SHERIDAN SUBDIVISION

APPLICATION NUMBER 4 DATE October 2, 2014

REQUEST Subdivision

DETAIL SITE PLAN

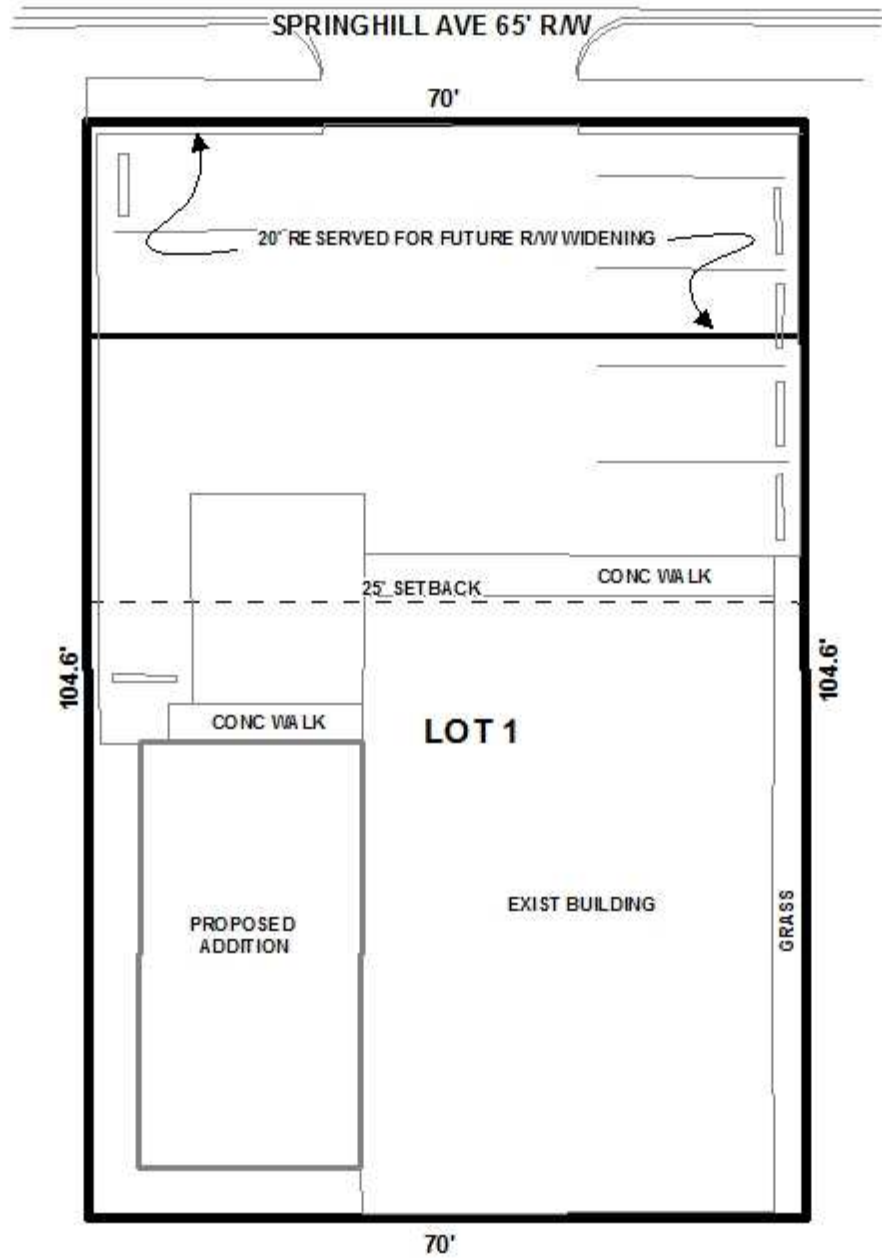
The lot size is not labeled on the preliminary plat. This information should be given in square feet and acres, and should be placed on the Final Plat, if approved. However, it should be noted that the proposed lot would exceed the minimum required lot size in Section V.D.2. of the Subdivision Regulations.

The site has frontage onto Spring Hill Avenue, a major street, which is illustrated as having a right-of-way of 65'. The preliminary plat shows a 20' wide strip "reserved for future right-of-way widening", which will result in Spring Hill Avenue having a right-of-way of 52.5' from the centerline; this portion should be dedication to the City of Mobile with the recording of the Final Plat, if approved.

As a mean of access management, a note should be placed on the Final Plat stating that the lot is limited to the existing curb cut, with the size, design, and location of the curb cuts, to be approved by Mobile County Engineering and conform to AASHTO standards.

The preliminary plat does depict the 25-foot minimum building setback line, required by Section V.D.9. of the Subdivision Regulations. The setback line should be retained on the Final Plat, if approved.

- 1) retention of the dedication to provide
- 2) placement of the lot size in square feet and acres;
- 3) placement of a note on the plat stating that the site is limited to the existing curb cut, with the size, design and location to be approved by Traffic Engineering, and to comply with AASHTO standards;

- 4) depiction of the 25-minimum building setback;
- 5) compliance with Engineering comments (*The following comments should be addressed prior to submitting the FINAL PLAT for acceptance and signature by the City Engineer: Provide all of the required information on the SUBDIVISION PLAT (i.e. signature blocks, signatures, certification statements, written legal description, required notes, legend, scale, bearings and distances) that is required by the current Alabama State Board of Licensure for Professional Engineers and Land Surveyors. Add a note to the SUBDIVISION PLAT stating that a Land Disturbance permit will be required for any land disturbing activity in accordance with the of the Storm Water Management and Flood Control Ordinance (Mobile City Code, Chapter 17 , Ordinance #65-007 & #65-045), latest edition. Add a note to the Plat stating that the approval of all applicable federal, state, and local agencies (including all storm water runoff, wetland and floodplain requirements) will be required prior to the issuance of a Land Disturbance permit. Revision of the plat to label each lot with its size in acres and square feet, or the furnishing of a table on the Plat providing the same information. Provide a written legal description for the proposed subdivision and matching bearing and distance labels.*)
